**Town of Hilton Head Island
Regular Design Review Board Meeting
Tuesday, June 12, 2018 – 1:15 p.m.
Benjamin M. Racusin Council Chambers
AGENDA**

Town of Hilton Head Island
Minutes of the Design Review Board Meeting
May 22, 2018 at 1:15 p.m.
Benjamin M. Racusin Council Chambers

EXTERIOR FACADE RENOVATION
SHELTER COVE PLAZA
50 SHELTER COVE LANE
HILTON HEAD ISLAND, SC 29928
CNNA ARCHITECTS, INC.

Sheet Title:
PROPOSED SITE PLAN

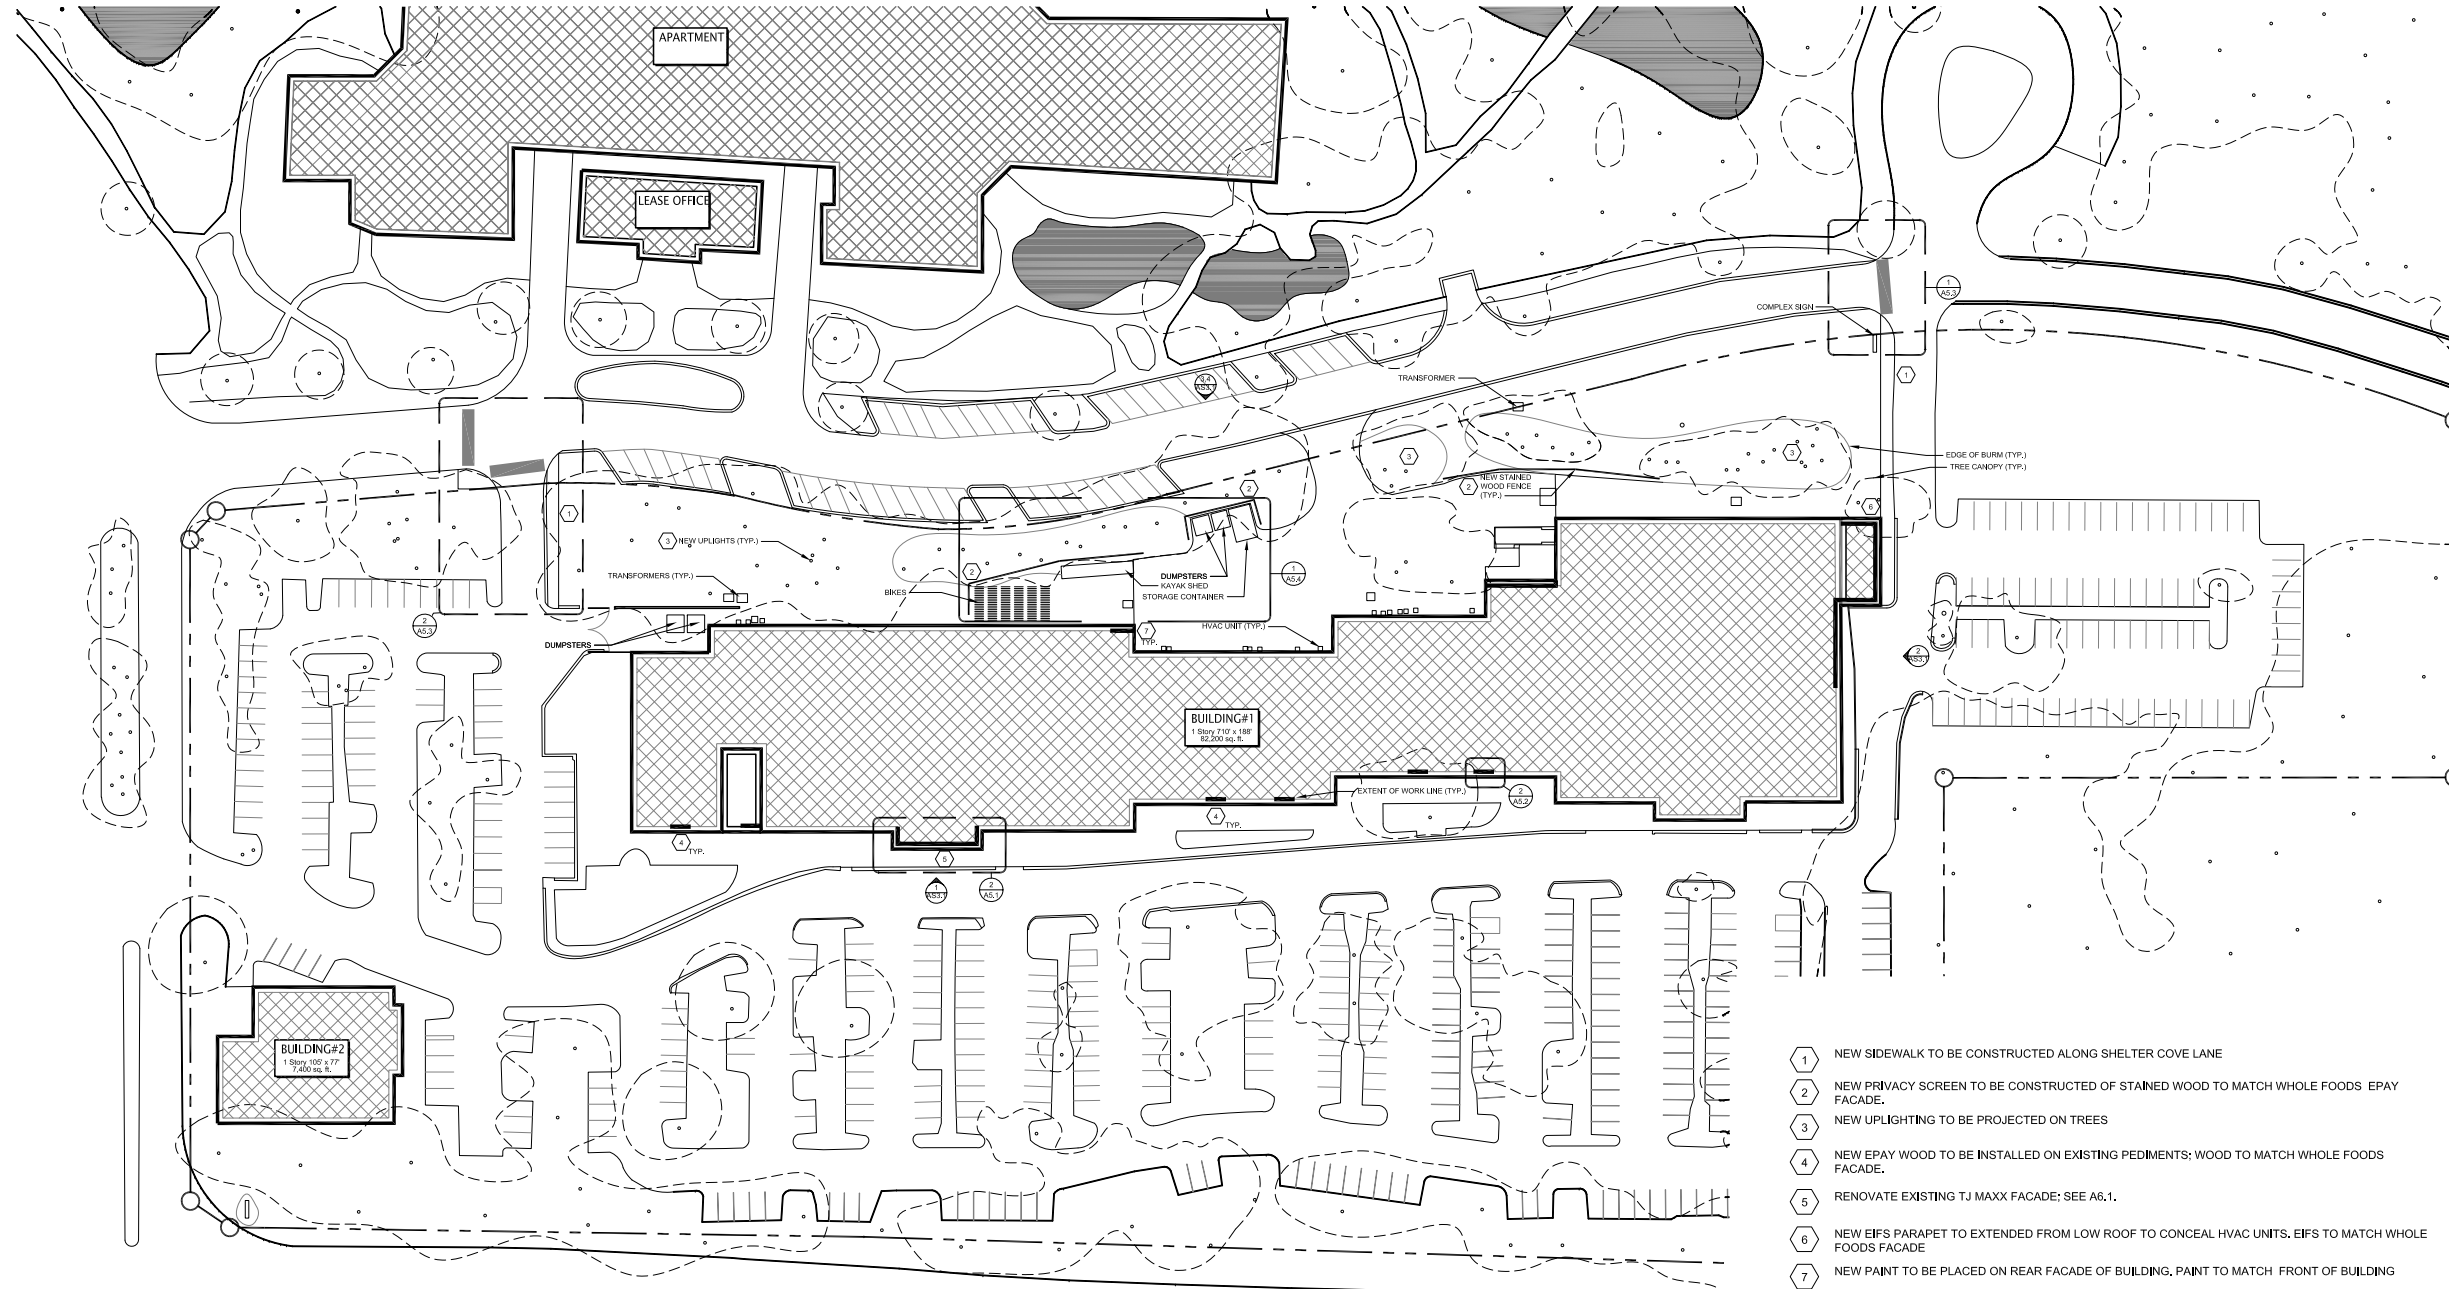
RECOMMENDED CONDITIONS: Remove the tree uplights.
